February 29, 2016

**Re: Hazeltine Mine, DRMS Permit No. M-2004-031,
Permit Amendment Application No. 1 (AM-01),
Preliminary Adequacy Review**

Figure 1: Map of the Hazeltine Mine, Wells MW-2, MW-3 and MW-11B are shown on the map, the proposed location of the Permanent Plan is also identified (all locations are approximate).

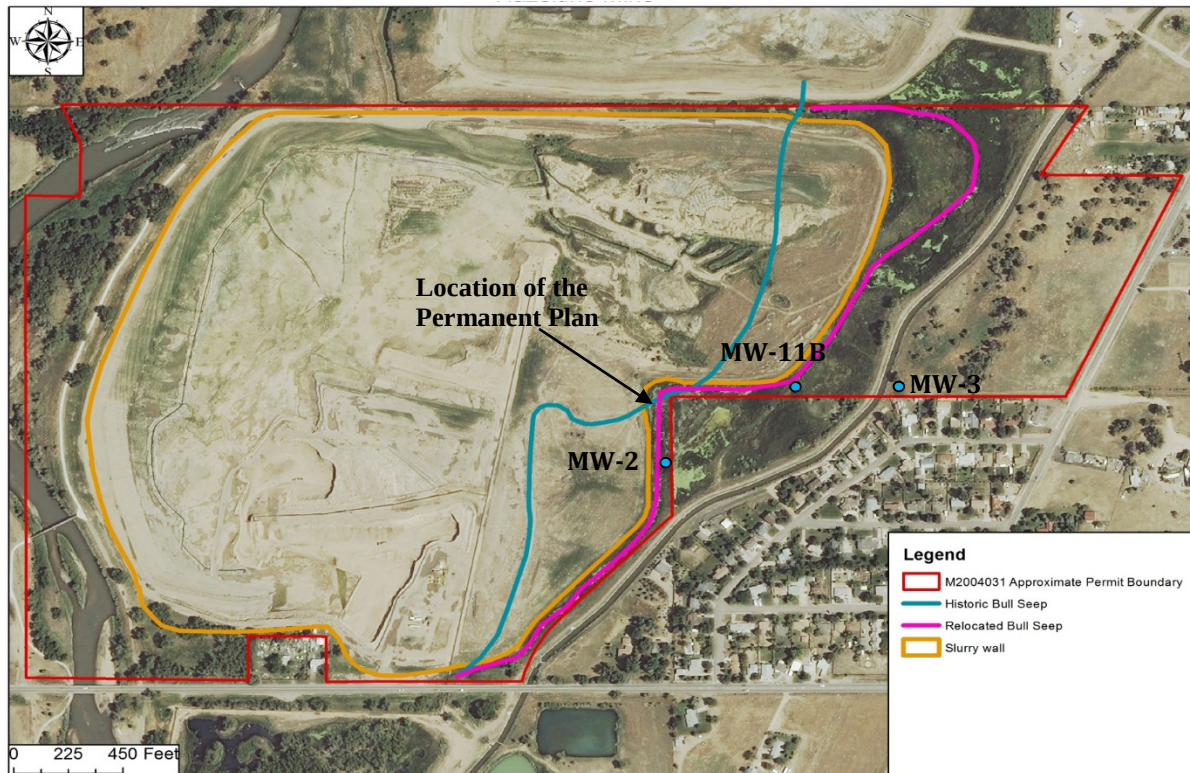
- 1) Through AM-01, the Operator attempts to satisfy the corrective actions of Violation No. MV-2015-003, regarding the submittal of a plan for permanent mitigation of groundwater mounding, Permanent Groundwater Mounding Mitigation Plan (Permanent Plan). The plans proposed through AM-01 calls for setting two 18-inch ADS pipes in the Bull Seep to divert surface water into the lined reservoir. The plans proposed in AM-01 addresses surface water flow in the Bull Seep and has no effect on mitigating groundwater mounding because the pipes are set at the land surface.

Monitoring wells MW-2, MW-3, and MW-11B are proximal to the location of the proposed Permanent Plan and represent the pre-mining/pre-slurry wall groundwater elevations in the immediate area. Prior to the installation of the slurry wall the average groundwater elevation for monitoring well MW-2 was 5035.96 feet (5.63 feet below ground surface); well MW-3 was 5,037.69 feet (10.58 feet below ground surface); and well MW-11B was 5,036.9 feet (2.63 feet below ground surface).

The Permanent Plan proposes setting the invert elevation of the two 18-inch ADS pipes at ground surface, at an elevation of 5,038.8 feet in the Bull Seep. The Permanent Plan appears to address surface water at an elevation which is significantly higher than the average pre-mining/pre-slurry wall groundwater elevation observed in monitoring wells MW-2, MW-3, and MW-11B. Therefore, the proposed Permanent Plan fails to minimize the impacts to the prevailing groundwater system as required by C.R.S. 34-32.5-116(4)(h), Rule 3.1.6 and the corrective actions of Violation No. MV-2015-003.

Pursuant to C.R.S. 34-32.5-116(4)(h), Rule 3.1.6, and the Board Order, please provide a Permanent Plan that will lower the groundwater elevation along the eastern portion of the Hazeltine Mine to an elevation that matches or closely mimics the average pre-mining/pre-slurry wall groundwater

elevation observed in monitoring wells MW-2 and MW-11B. The Applicant will also need to provide a hydrologic demonstration in the form of a draw down model, which demonstrates that the effects of the Permanent Plan will lower the groundwater elevation in the vicinity of MW-3 to near the average pre-mining/pre-slurry wall groundwater elevation observed in MW-3.
